ERRATA

K24 Development Kit – Revision 1

Capacitors to Remove

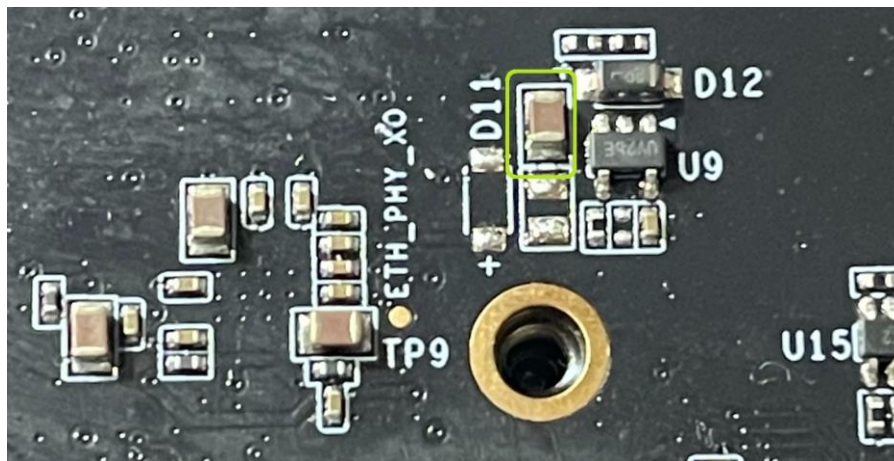
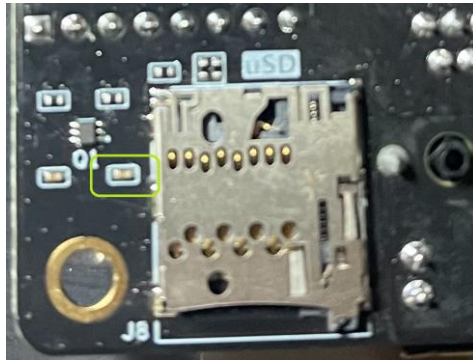
Description – There appears to be a reliability issue with the Ethernet during reset. In the cases where the Ethernet reliability issue occurs, software may not properly detect the Ethernet PHY.

Workaround – To overcome the reliability issues with Ethernet, there are a couple of recommendations. First, it has been found that removing capacitors C12 and C51 from the K24 IO Carrier Card yielded a more reliable Ethernet reset signal.

C51 Location on Board Bottom Side – Green Box

C12 Location on Board Bottom Side – Green Box

If user is not comfortable or capable of making the modifications to remove the two capacitors from the printed circuit board, they should contact customize@avnet.com to get the board repaired. Please reference Ethernet Capacitor Removal for K24 Development Kit.

Ethernet PHY DTS Settings for KSZ9131 PHY

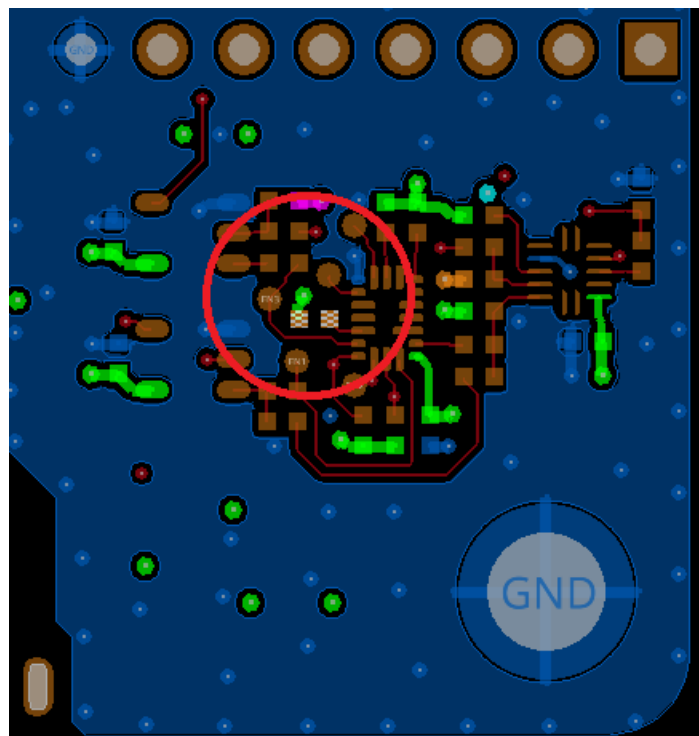
Also, there is software control of the Ethernet Reset that is required to be generated. Depending on the implementation of Ethernet, the user can provide software control to the Ethernet reset signal by utilizing the MIO12_ETH_RST_N signal that is attached to the processor via GPIO control of MIO Pin 12. MIO Pin 12 maps to the K24 System-On-Module to physical pin K20:

For Linux applications using the KSZ9131 PHY drivers, a reset pin can be added as follows in the device tree (DTS):

With the two capacitors removed and the reset pin added for software control of the Ethernet reset it is found that the Ethernet interfaces functions in a reliable fashion.

R334 Location on Board Bottom Side – Red Circle

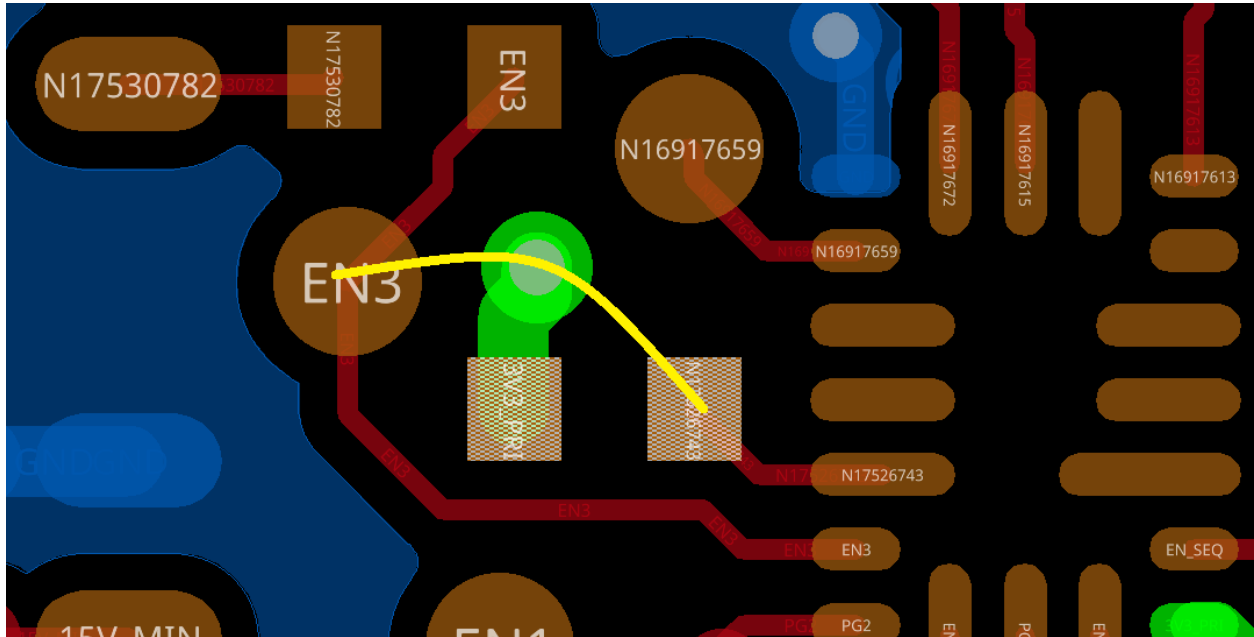
Description – There is an issue with the implementation of the on/off sequencer U22 (SLG7TD43741VTR) that prevents the board from completing it's power down sequence following the long depress of push button PB7. This failure mode is indicated by the PG LED D26 remaining illuminated no matter how long push button PB7 is depressed.

Physical Workaround - To get the proper power down functionality, resistor R334 needs to be removed and a wire needs to be added from TP44 (EN3) to R334 signal pad. In essence this shorts EN3 to PG3 on U22.

Wire from TP44 (EN3 Test point) and R334 Signal Pad on Board Bottom Side – Yellow Line

Workaround – A user can power-off the board by removing the power supply Type-C Cable from jack J11.
